R44 SERVICE BULLETIN SB-80

SUBJECT: Pop-Out Float Cylinder Valve

ROTORCRAFT AFFECTED: R44 and R44 II helicopters with pop-out floats (Clippers), and spare pop-out float cylinders, equipped with D757-1 (gray) valve assembly containing D758-1 Revision C or prior housing assembly (Revision letter follows stamped part number). Black valves are not affected.

FIGURE 1

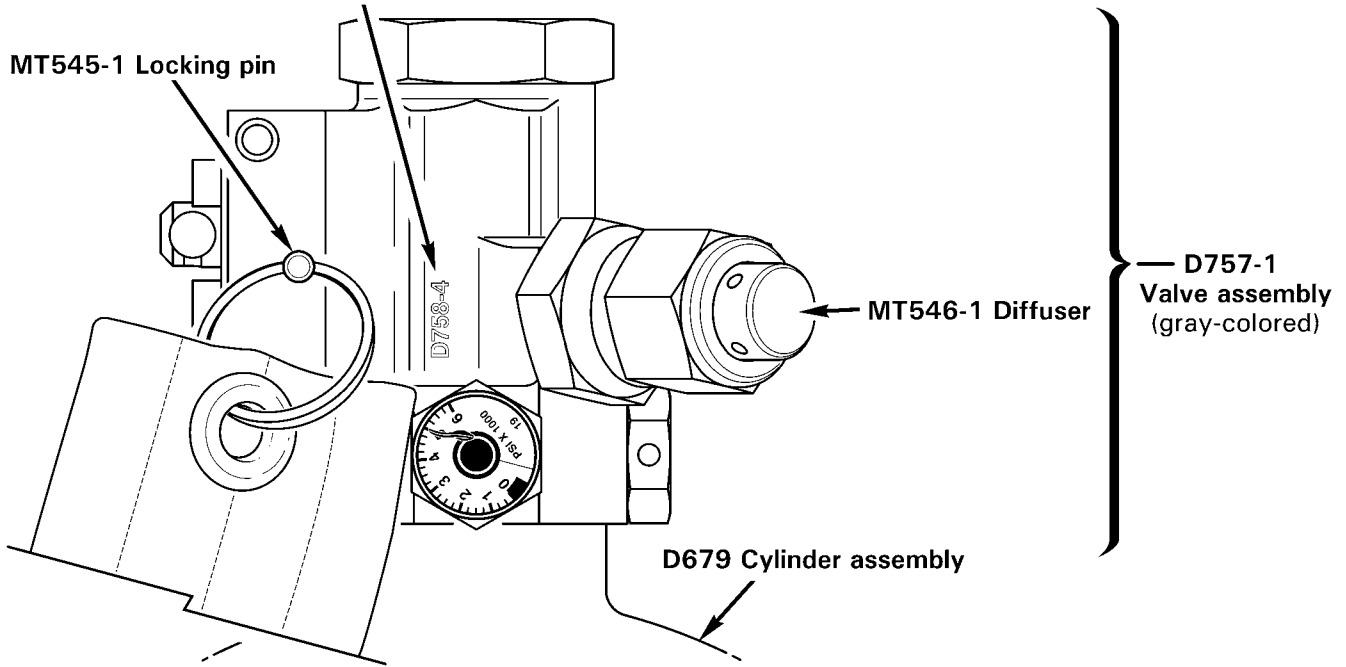
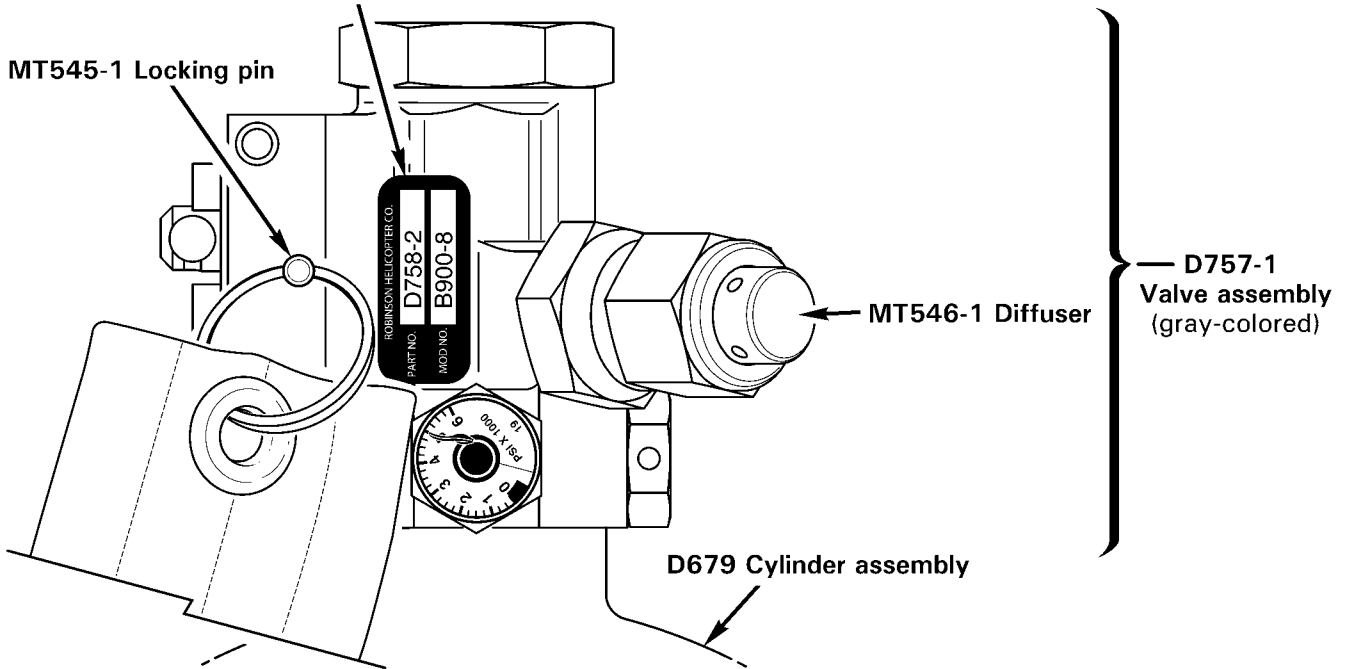
1. Refer to Figure 1. If D757-1 (gray) valve assembly is engraved with "D758-4," or if gray valve has a data plate indicating B900-8 modification, the requirements of this bulletin have been complied with and no further action is required.
2. If gray valve is not engraved with "D758-4" or does not have a data plate indicating B900-8 modification:
 - a. Verify a local facility (such as a welding gas supplier) is available to fill cylinder with 5000 psi helium and order one KI-211 Valve Replacement Kit, or
 - b. Order one D679-3R (filled, overhauled-exchange) cylinder assembly.

D758-4 Housing part number
will be engraved adjacent to
pressure gage.

Data plate indicating B900-8
modification will be located
adjacent to pressure gage.

6. As required, lightly coat A215-212 o-ring with A257-19 lubricant and install o-ring on valve at base of threads. Install D757-1R valve assembly in cylinder and special torque valve at 1-3/8 inch wrenching flats to 40 ft-lb.
7. Follow KI-151 kit instructions when filling and installing cylinder assembly.
8. Make appropriate maintenance record entries.
